From: John Cappello
To: IPART; WICA Mailbox
Subject: Submission - Box Hill North Retail Variation 2019
Date: Wednesday, 29 January 2020 7:29:15 PM
Attachments: [REDACTED]

Box Hill North Network Variation 2019 - Flow Systems Operations Pty Ltd

Figure 1: Properties not within Flow Systems' Service Agreement

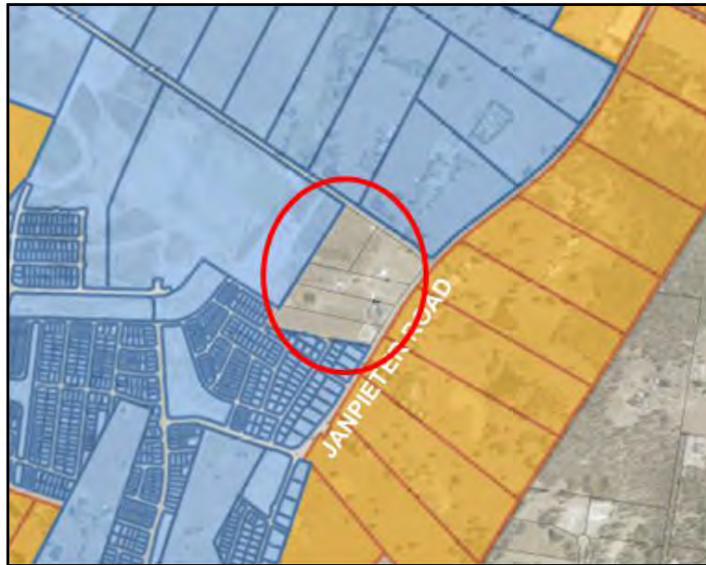
As part of Council's assessment of the planning proposal to permit Flow Systems' water management facility in Box Hill North, the proponent was required to demonstrate that the facility would have capacity to accommodate the anticipated demand by all future development within the Precinct, including land not controlled by the major developer, Celestino. However, it is noted that the existing RSL does not apply to a number of properties along Red Gables Road / Janpieter Road (circled red in the figure below). It is unlikely that these properties would be able to provide services to their developments through other providers as the cost of providing the necessary infrastructure to service their individual developments would be prohibitive. Accordingly, they have limited options other than engaging with Flow Systems to provide the required services.

Council is currently assessing a number of subdivision applications relating to these properties where Flow Systems has been reluctant to provide any commitment with regard to supply and timing of water related infrastructure required to facilitate redevelopment. This has created significant uncertainty and delay in the development assessment process and concern that Flow Systems is failing to honour its commitment to provide services to all properties within the Box Hill North Precinct. Prior to Flow Systems extending services to additional customers outside of the Precinct, it should first provide certainty to the owners of existing urban land within the Precinct, in line with previous commitments and the premise upon which the rezoning of the water management facility was supported. Accordingly, it is recommended that Flow Systems be required to include these additional properties within the RSL area (for both recycled water and sewer services) to reflect Flow Systems' commitment to reasonably service these properties within a timely manner.

Figure 2: Land zoned RU6 Transition adjacent to the Box Hill North Precinct

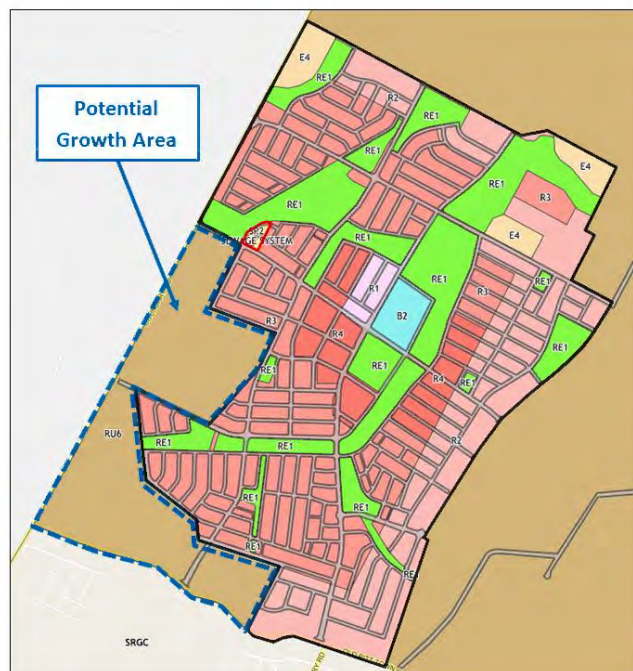
The proposal from Flow Systems appears to be a short term solution to removing excess treated water from the overall system. It does not take into account potential future growth in the area and lots that may require services should they be released in the future. The proposed inclusion of an additional 38 lots would remove the need for Flow Systems dispose of this excess water through other means (potentially through gaining a license to dispose water into the creek adjacent to the Local Water Centre) without these additional lots gaining the benefit of a sewerage treatment system.

Land identified in Figure 2 is currently zoned RU6 Transition and adjoins the Box Hill North Precinct. Some of this area may be suitable to accommodate future urban development, subject to detailed strategic investigations and the planning proposal process. Flow Systems has based their expansion on current land use zoning only, without consideration of the potential future release of this land. It is recommended that any infrastructure extension of the RSL be considered in light of these potential future residences that may require access to both water and sewerage in the future.
